CBD & SOUTH EAST LIGHT RAIL PROJECT

(RANDWICK CITY COUNCIL & UNSW AREA)

TECHNICAL REVIEW – TRAFFIC ENGINEERING & ROAD SAFETY (DECEMBER 2013)

Figure 9: Proposed Conditions - Wansey Road / High Street

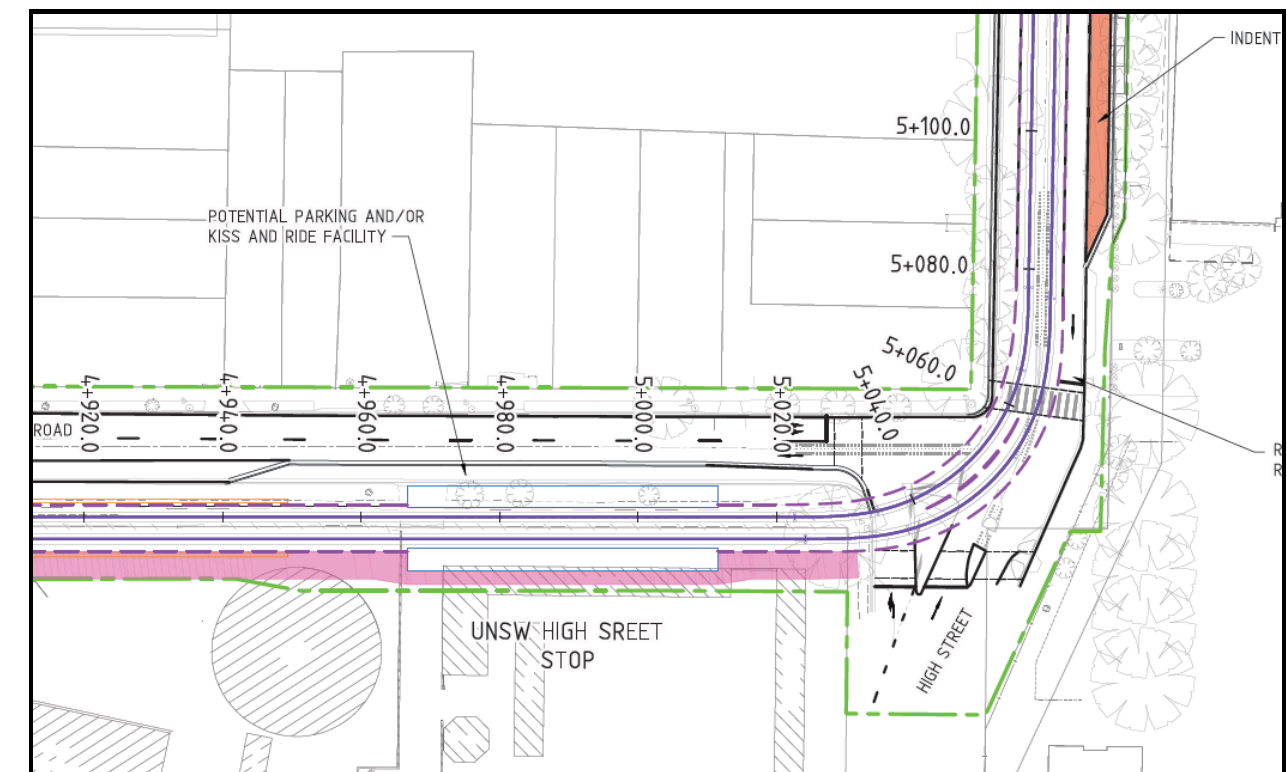
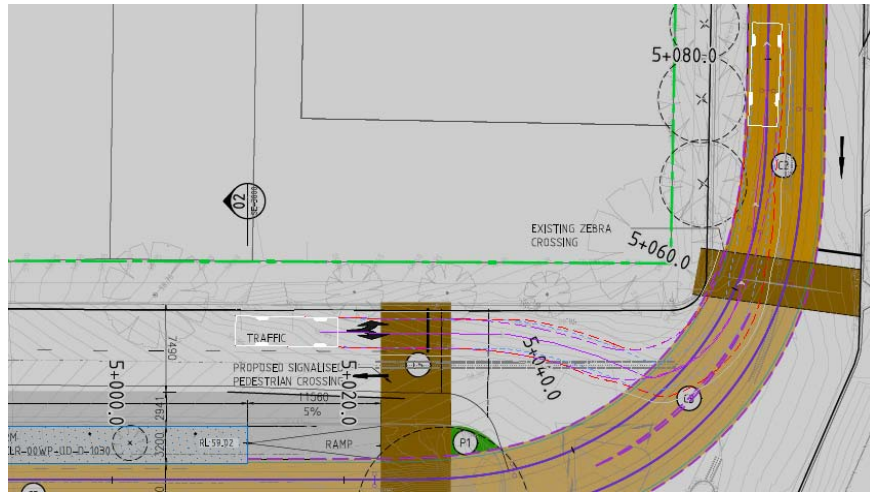
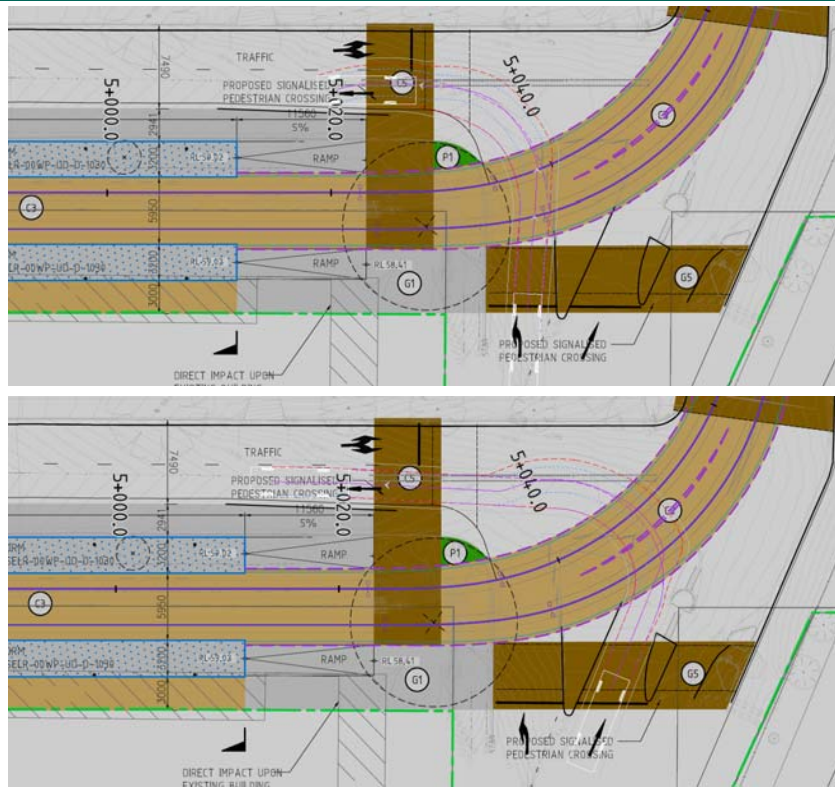
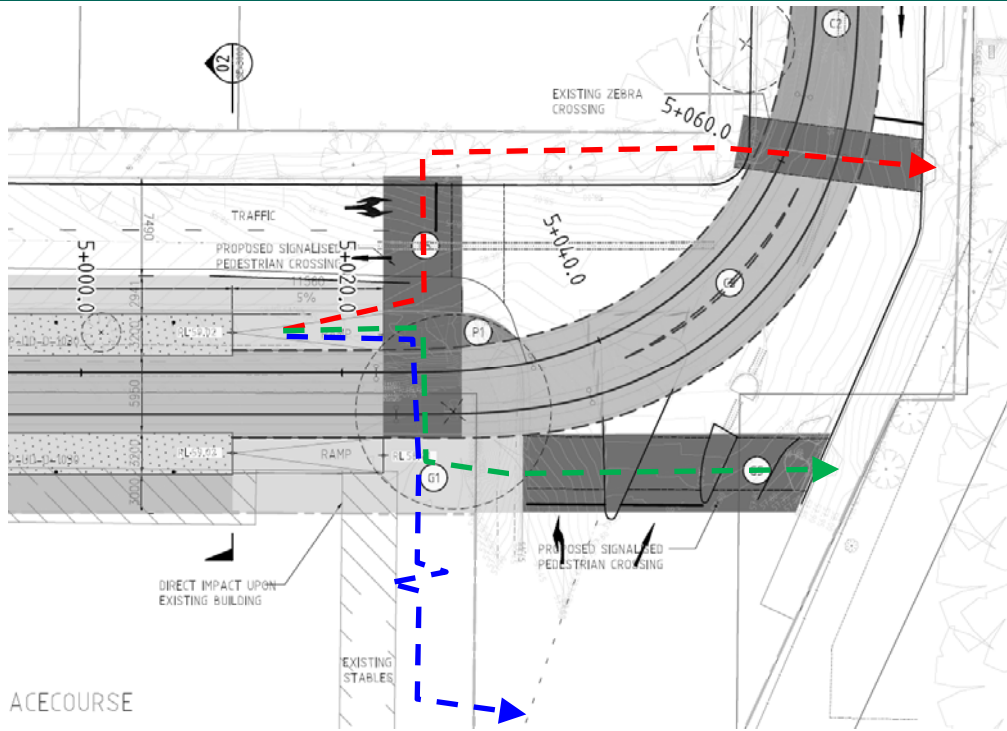
Category	Sub-Category	Proposed Conditions	Issue / Comment	Potential Alternative / Mitigating Measure
Consistency	-	-	The 'Road Engineering' plans and the 'Stop Plans' show different configurations for the pedestrian crossings. It has been assumed that the Stop Plans are the basis for comment.	Update plans to be consistent.
Location	Surrounding Land Uses	Located at north east corner of UNSW campus, on north side of High Street.	Proposed stop is located adjacent to UNSW campus, a major passenger generator.	Nil – not enough room in High Street to locate tracks, stops and traffic lanes.
	Land Acquisition	Required from Randwick Racecourse on west side of Wansey Road.	Nil.	Nil.
Layout	Track Location	Tracks located on west side of Wansey Rd and centre of High Street.	Track curves require tracks to be located on west side of Wansey Road. Additional land acquisition would be required from residential properties on north east corner of intersection to realign track curves.	Nil.

Platform Size	Both platforms 45.0m x 3.2m = 144.0 sqm.	<p>Assumption: LRV at 2-3 minute frequencies at CBD end will result in LRV at 4-6 minute frequencies at this location. Assume approximately 3 LRV each 15 minute period.</p> <p>Alighting:</p> <p>Assuming a capacity of 300 pax per LRV, should be no more than 300 pax alighting at any one time. Capacity of platforms to cater for peak alighting numbers (approx. 632 pax in 15 minute period).</p> <p>Using the Fruin Level of Service criteria, the ramp (average flow rate of 42 pax per minute) is expected to operate with a Level of Service of A. However, if 211 pax alighted from one LRV, the Level of Service would drop to E.</p> <p>Boarding:</p> <p>Capacity of platforms to cater for peak boarding numbers (approx. 480 pax in 15 minute period).</p> <p>Using the Fruin Level of Service criteria, this platform is expected to operate with a Level of Service of D (129 pax waiting for LRV).</p> <p>The ramp (average flow rate of 26 pax per minute) is expected to operate with a Level of Service of A. However, the signalised crossings will meter the flows of pedestrians.</p>	<p>Alighting:</p> <p>Proposed outbound platform ramp will restrict flow off the stop and will 'meter' pedestrians reaching the crossing points. However, predicted flow rates are expected to be within capacity.</p> <p>Boarding:</p> <p>Proposed citybound platform will be very congested (Level of Service F) with some pax being required to wait on ramp and approaches.</p>

Storage	Ramps provided at both north and south ends to provide access.	Ramps and approaches will provide additional storage if stops are congested. Road safety risk is if pax cannot clear light rail tracks or roads. As the citybound stop will have the highest boarding numbers, the ramp and large storage area is expected to accommodate all required pax without queuing across the light rail tracks and roads.	Nil.
	Swept Paths	The proposed tracks and stops will reduce the width of Wansey Road and High Street.	<p>North to east left turns (from Wansey in to High) – very tight radius, turning vehicles may encroach on to citybound light rail tracks.</p> 	Ensure design vehicles able to undertake turn. If cannot undertake turn, stop line on east leg of intersection may need to be set back.
			West to north left turns (from High in to Wansey) – very tight radius, turning vehicles may encroach on to southbound traffic lane or mount footpath, potential conflict with pedestrians if right turners allowed turn at same time as pedestrians.	Ensure design vehicles able to undertake turn. If cannot undertake turn, consider removal of the left turn slip lane and allow left turns from the eastbound 'through' lane. The left

Category	Sub-Category	Proposed Conditions	Issue / Comment	Potential Alternative / Mitigating Measure
				<p>turn slip lane could then be used as a larger pedestrian area and reduce the width of the crossing across the west leg of the intersection. The Wansey Road stop line could then also be moved further south.</p>
			North to east right turns (from Wansey in to High) – very tight radius, turning vehicles may encroach on to waiting areas, may impact on parking along High Street, potential conflict with pedestrians if right turners allowed turn at same time as pedestrians.	Ensure design vehicles able to undertake turn. Review conflict with pedestrians – consider early start for pedestrians on crossing.
			LRV clearances increase around tight radii. Turning LRV may encroach in to pedestrian crosswalks and waiting areas.	Ensure adequate clearances to turning LRV around curves and modify crosswalks and waiting areas to suit.

Westbound through movements have poor delineation through intersection.	Build out southern side of High Street out to existing kerb outstand.
Access	Crossing Points	<p>The 'Road Engineering' plans and the 'Stop Plans' show different configurations for the pedestrian crossings.</p> <p>Signalised Pedestrian Crossings are proposed at Wansey Rd/High St intersection, across Light rail tracks (at north and south ends) and also across Wansey Rd at north end of stops.</p>	<p>A key design consideration must be the movement of pedestrians to and from the stops. In the AM Peak, there will be a very high movement of pedestrians from the southbound platform, down the ramp, and then across the roads at the signalised access points. Even though these movements are to be controlled by signals, it is expected that pedestrians will cross the tracks and roads against the signals. Therefore, although signalised crossings are required for the road crossings, the crossings of the tracks should be 'LRV priority crossings' which will allow pedestrians to cross as required except for when LRV are present.</p> <p>As the stops are located on the north side of High Street, pedestrians to UNSW will be required to either:</p> <ul style="list-style-type: none"> cross Wansey Road and High Street, cross tracks then High Street, or cross tracks, walk westbound along High Street then cross at zebra crossing. 	<p>Agree that road crossings should be signalised.</p> <p>Recommend that crossings of the tracks should be unsignalised with priority given to LRV. Electronic signs could be used to provide increased warning of an approaching LRV e.g. 'GIVE WAY TO LIGHT RAIL VEHICLE'</p> <p>The removal of the left turn slip lane could increase the storage areas for pedestrians and reduce the crossing width.</p> <p>The southbound shared path ends just north of High Street. Shared path users will need to share this space with large numbers of pedestrians. Provide a surface treatment that clearly delineates the end of the shared path and warns of pedestrians.</p> <p>Consider an alternative access down northern side of High Street to a new pedestrian overpass to provide direct connection in to UNSW campus.</p>

Category	Sub-Category	Proposed Conditions	Issue / Comment	Potential Alternative / Mitigating Measure
			 <p>It is noted that the existing zebra crossing on High Street to the west of the Wansey Road intersection (as shown in Figure 6) is used by a large number of pedestrians (mostly bus passengers) and UNSW has safety concerns regarding its operation. Adjacent to this zebra crossing is a raised walkway into UNSW's grounds. A potential future option is to create a pedestrian overpass (to replace the zebra crossing) that connects directly to the raised walkway within UNSW. This option would mean that a significant number of LRV pax would only have to cross the tracks and no roads.</p>	
	Ramps	DDA compliant ramps provided at both north and south ends to provide access.	The ramps end at the crossing points which may create congestion as pedestrians wait to cross the tracks or Wansey Rd.	Shorten ramps if possible to create larger waiting areas prior to cross points.

Illegal Access	No fencing has been shown.	The crossing at northern end important to provide access to from residential area and park and ride. Illegal or undesirable crossings are expected to occur between the shared path, track and park and ride footpath (especially during the AM Peak).	Install fence between shared path and tracks (to protect shared path users from opposing LRV), and between park and ride footpath and tracks (to prevent pedestrians crossing tracks away from formal crossing points).
	Safety	-	Illegal access is the main safety issue as discussed above.	Nil.
	Footpath / Shared Path	4.0m shared path on Wansey Road narrows to 3.0m past platform.	Shared path ends at southern end of platform. Shared path users, especially cyclists, will enter an area with significant numbers of pedestrians.	Nil – 3.0m is desirable width for shared path. Ensure path material and signage indicate end of shared path. Consider installation of bicycle lanterns for crossing of High Street to allow cyclists to cross without dismounting.

Vehicle	-	University access restricted to left in/left out.	Nil.
Intermodal	Sharing of Tracks	-	n/a	n/a
	Bus Stops	Westbound bus stops (indented bays) proposed on south side of High Street east of intersection.	Proposed stop will replace a number of existing bus stops in High Street.	Nil.
		Eastbound bus stops retained on north side of High Street west of intersection.	Nil.	Nil.
	Bus / LRV Transfer	-	It is noted that some bus stops will be retained, and passengers may transfer to LRV. These passengers likely to cross High Street then Wansey Road.	Nil.

Category	Sub-Category	Proposed Conditions	Issue / Comment	Potential Alternative / Mitigating Measure
	Bus Priority	No bus priority shown on plans.	LRV and pedestrian priority likely to be highest priorities, so unlikely to be able to also provide bus priority. In addition, buses will not be located in separate lanes so additional priority unlikely to be effective.	Nil.
Signal Operation	Overview	No details provided.	<p>Separate phases likely to be required for High Street throughs, Wansey Road left/right, and tram movements. Some other movements (vehicle and pedestrian) could run with LRV phases. Some traffic movements conflict with pedestrian movements.</p> 	Review phasing to determine optimal operation for LRV and pedestrians.
	LRV Movements		<p>Signalised left and right turn movements. LRV movements could run separately. May not want green for pedestrians across Wansey Road at same time as LRV movements as pedestrians may observe green walk signal and think it applies to the crossing of the tracks.</p> <p>Need to determine southbound trams 'trigger' signals. The time at stops is variable and only want to provide time to LRV phases when needed. Providing advance detection of east leg will be possible. Advance detection on north leg not possible due to proximity of stop. So when LRV detected, need to be able to 'close' down other phases as quickly as possible. The restriction on closing down phases will be pedestrian crossing clearance times. If pedestrian crossing can be as short as possible, this reduces the time required to 'stop' the pedestrian phase and switch to the LRV phase.</p>	<p>If crossing of Wansey Road is signalised and crossing of tracks is not, stagger the crossings so that pedestrians are required to change direction.</p> <p>Modify intersection to increase distance between light rail stop and crossing point to allow detection of southbound LRV.</p> <p>Modify intersection to reduce length of the pedestrian crossings.</p> <p>Signal operation should be set up to allow LRV phase to run between other phases to reduce delays.</p>

Bus Movements	Bus movements eastbound and westbound through intersection.	No additional priority.	Nil.
	Pedestrian Movements	Pedestrian Operated Signals and LRV Priority Crossings.	Some traffic and tram movements conflict, need to consider how they will be undertaken safely. One option may be to run an all pedestrian phase which allows pedestrians to cross in all directions at one time.	Consider an all pedestrian phase which allows pedestrians to cross in all directions at one time.
	Traffic Impacts	Right turn movement from east to north removed.	Northbound (left turn) and eastbound (through) traffic will share High Street with LRV. Although light rail tracks are separated midblock, right turning vehicles share the tracks.	Consider some form of traffic metering, especially in High Street east of intersection, to hold traffic in Wansey and/or High to reduce congestion for eastbound LRV. Note this may impact on High Street bus services.
